**BID**  
**ADDENDUM NO. 2**  
**TO**  
**CONTRACT DOCUMENTS**  
**AND**  
**TECHNICAL SPECIFICATIONS**  
**FOR**  
**2019 BOND REFERENDUM**  
**CAPITAL IMPROVEMENTS**  
**AT**  
**MAMARONECK HIGH SCHOOL**  
**PHASE 2**  
**NYSED #66-07-01-03-0-001-039**  
**BID # 20/21 – MUFSD-00**

**LAN Job #4.1092.72.06**  
December 23, 2021

2.0 Amendments to Specifications:

3.0 Amendments to Drawings:

**A2.10**

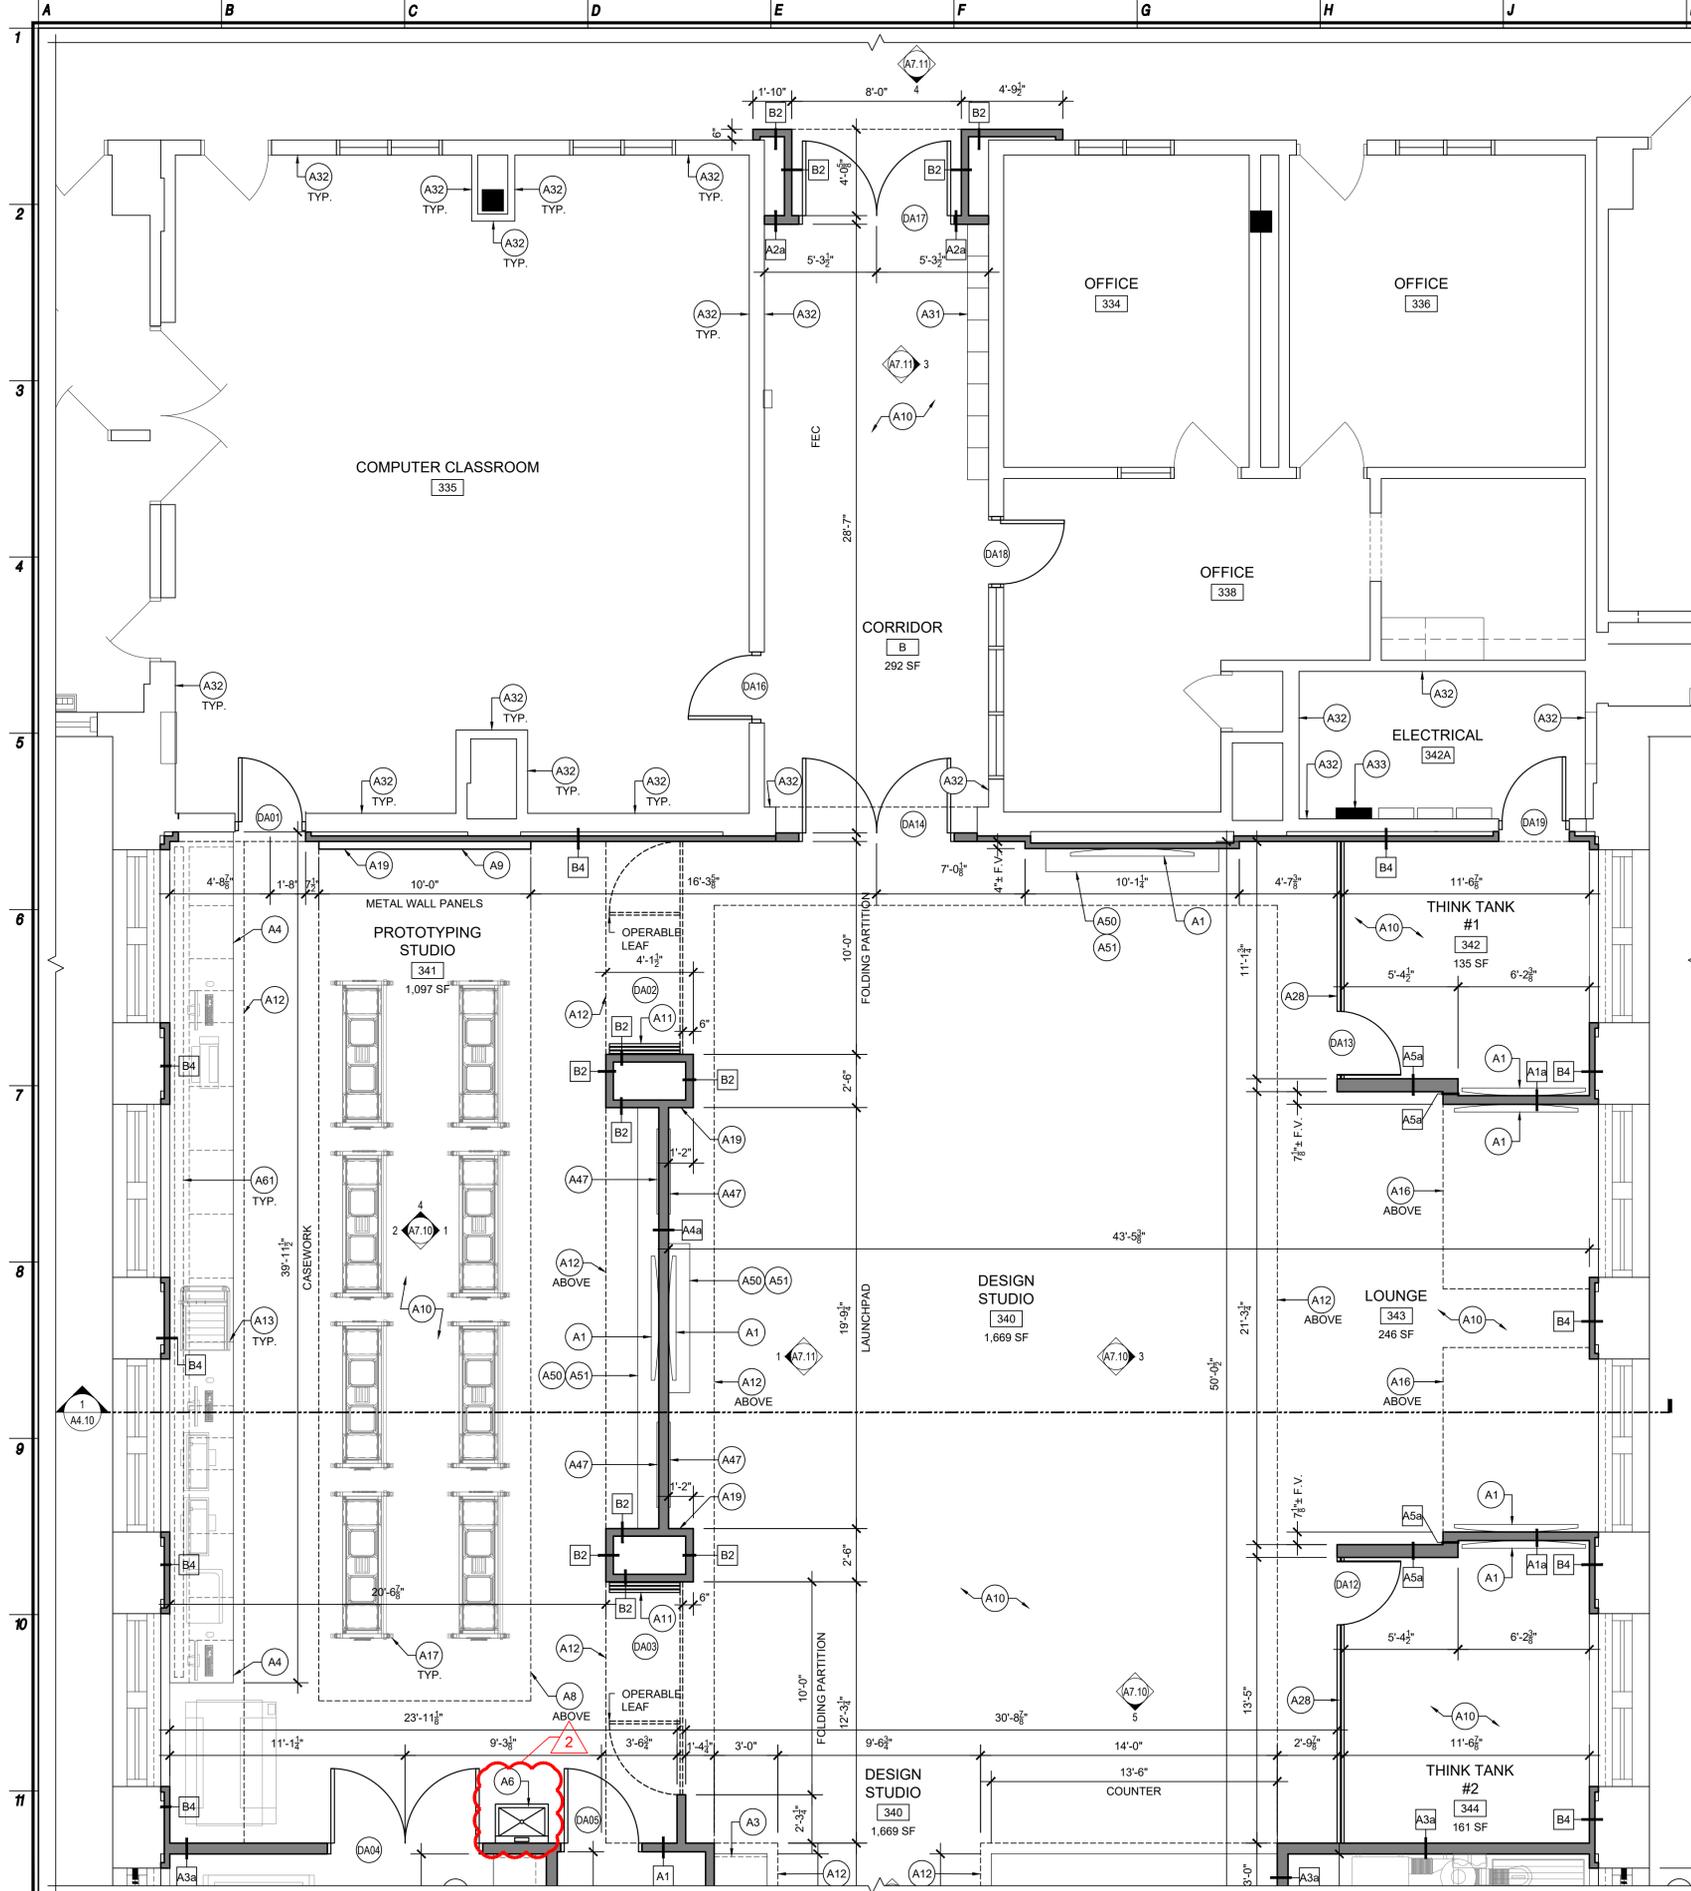
Drawing No.	Addendum Requirements
A 2.10 and A2.11	Floor Plans updated to reflect a new sink added in Prototyping Studio 341.
P1.12	Plumbing Floor Plan updated to reflect a new sink added to Prototyping Studio 341.
P1.13	Plumbing Fixture Schedule – STEAM Lab updated to reflect a new sink added to Prototyping Studio 341.
M1.81	Drawing revised to show existing gas piping to be removed by the Plumbing Contractor.  Additional notes referencing the separation of work between Prime Contracts were added to the drawings.

**M1.81**

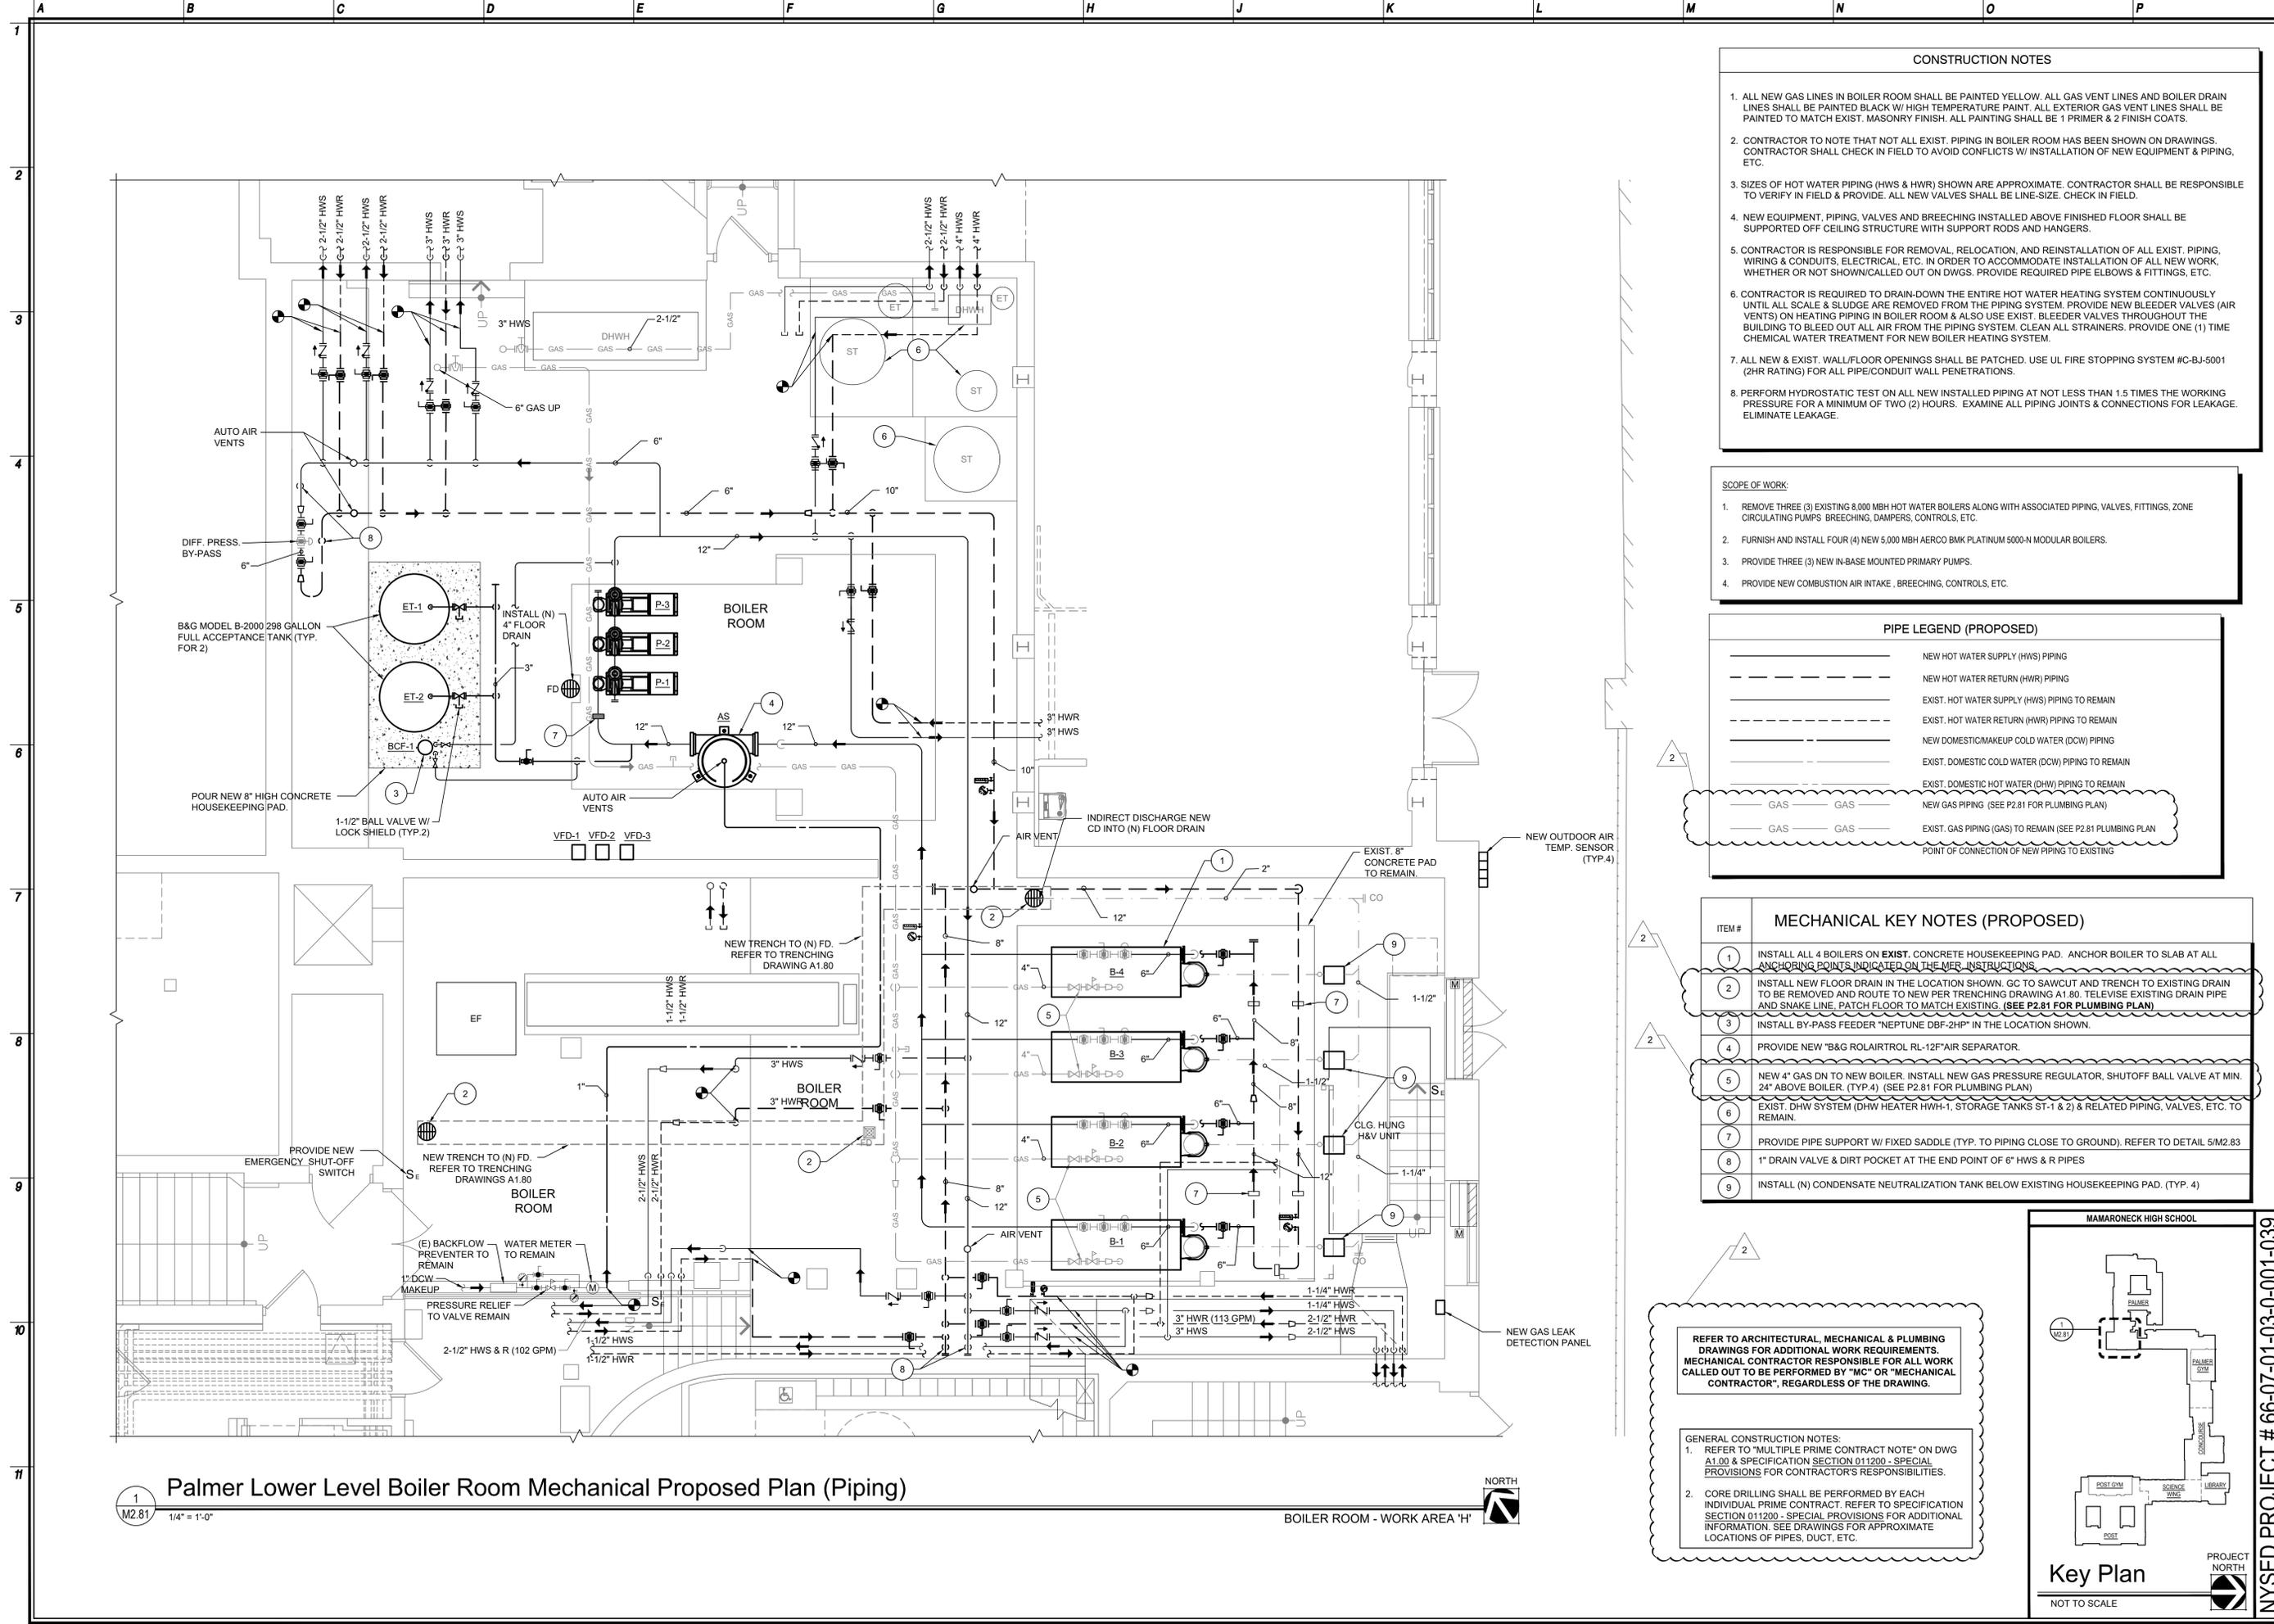
Drawing No.	Addendum Requirements
M2.81	Drawing revised to show new gas piping by the Plumbing Contractor.  Drawing revised to show new floor drains by Plumbing Contractor.  Additional notes referencing the separation of work between Prime Contracts were added to the drawings.
P2.81	New Drawing added to the set showing Plumbing scope of work associated with the Palmer Boilers (Work Area H).

**Palmer Lower Level Boiler Room Plumbing Proposed Plan (Piping)**  
 1 M2.81 1/4" = 1'-0"  
 BOILER ROOM - WORK AREA 'H'

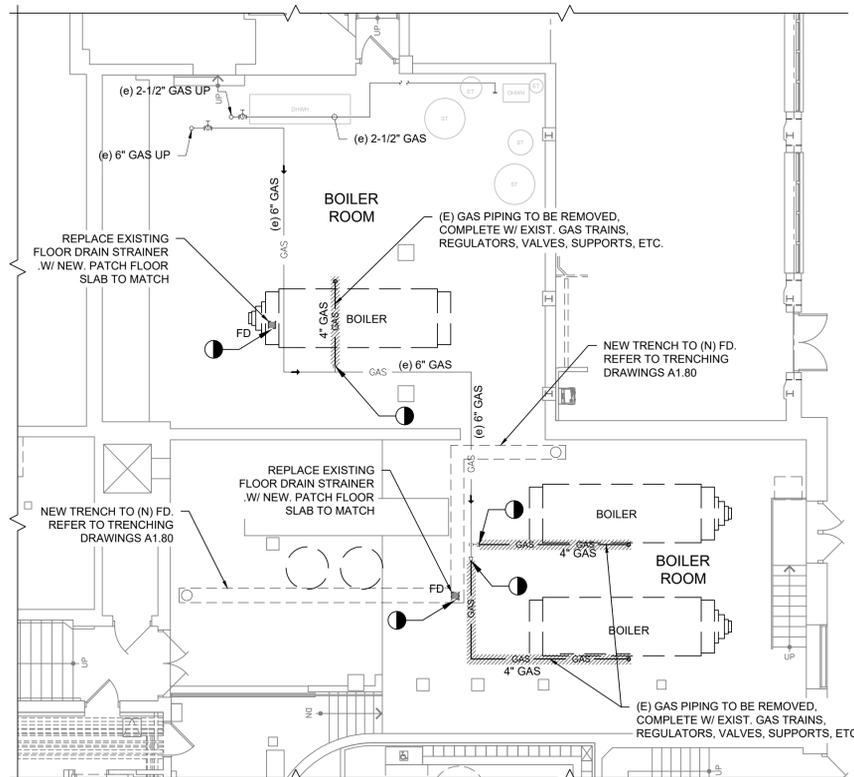
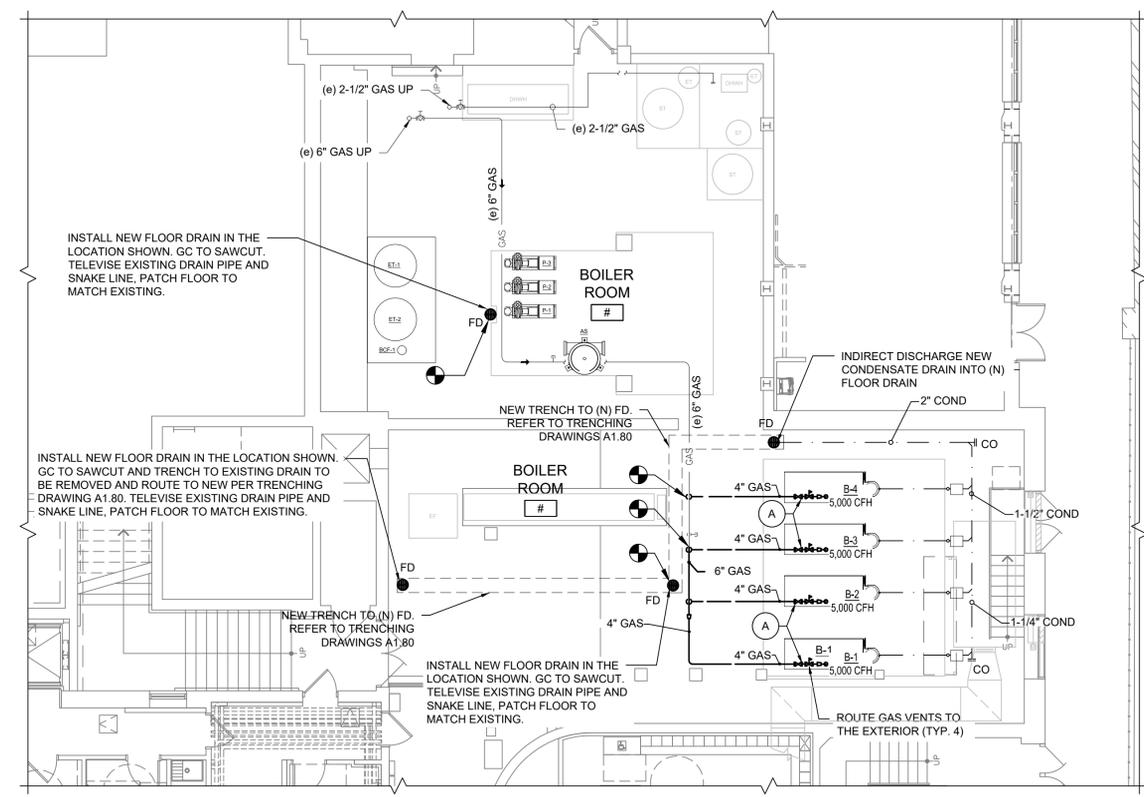
- Response: Second Shift is confirmed prior to 6/27. An early start will be discussed with the Owner, once the project is awarded.
- 6 Question: Palmer Boiler Room Trench Drain: Please refer to Contract Drawing M2.81 Key Note 2, please confirm installation of new floor drains including "televise existing drain pipe and snake line, patch floor to match existing", is by PC. Please refer to A1.80 which indicates this work is within the PC's scope. In addition, please confirm New Floor Drain indicated to be replaced on M2.81 near P-1 thru 3 is to be performed by others.

- Response: Scope of work for floor drawings is the responsibility of the Plumbing Contractor. A new plumbing drawing reflecting this work (P2.81) has been added to the drawing set.
